APPROVED MINUTES

January 20, 2022 Standards Committee Meeting

RE: Minutes from the January 20, 2022 Standards Committee Meeting

802-DMSS (existing -01 thru -23, shown markups) DYNAMIC MESSAGE SIGN STRUCTURE

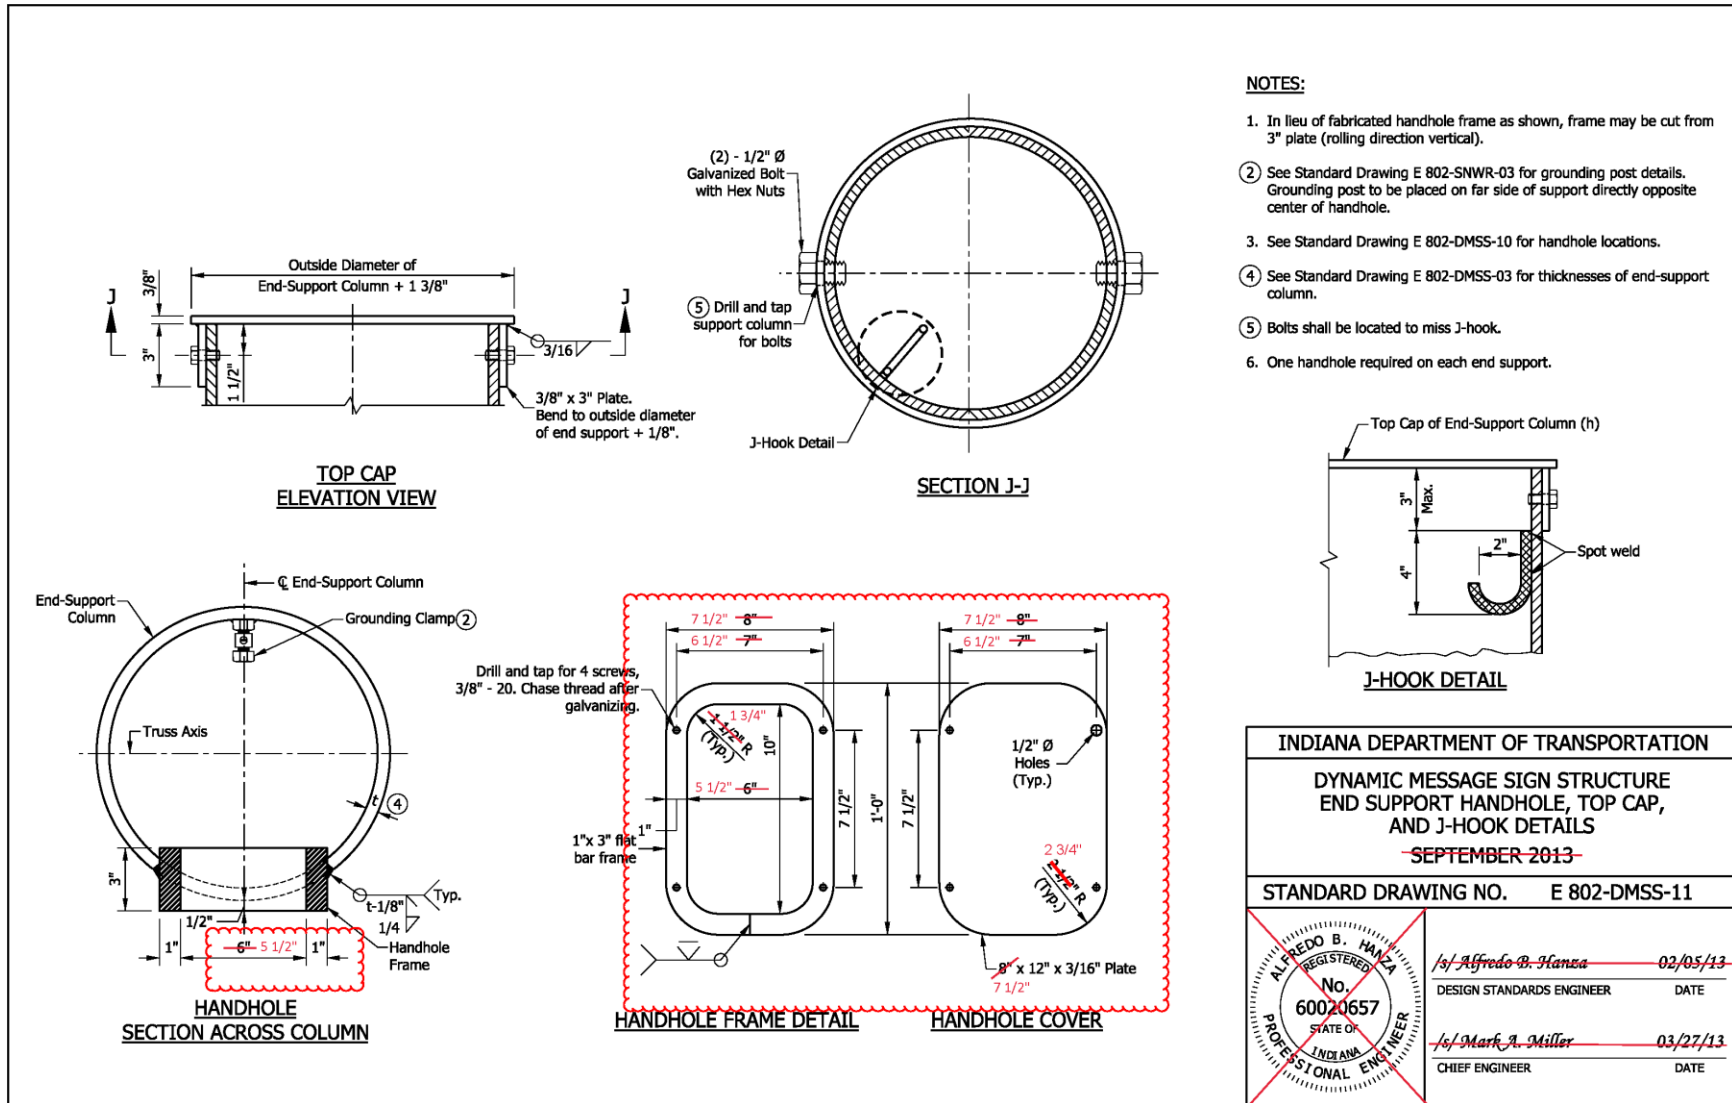
PROPOSED SOLUTION: Design the structures per latest AASHTO LRFD 2015 code, revise the standard drawings accordingly. Add detail on the proper anchor bolt hardware tightening order ("star pattern"). Add a detail for drain holes in the handrail post (DMSS series).

I.D. PLATE AND OTHER DETAILS
 ADDED TO SHEET

- ① See Standard Drawing E 802-DMSS-11 for handhole details.
2. See Standard Drawing E 802-DMSS-12 for anchor bolts and skirt details.
- ③ I.D. tag is a 1/8" stainless steel plate with the following information stamped in 1/2" black letters:
~~Manufacturer~~, ~~Drawing/Order #~~
~~Contract #~~, ~~Structure Type~~
~~Fabrication Date~~, ~~Structure Length~~
~~End Support Mounting Height~~
4. Each end support requires one I.D. tag.
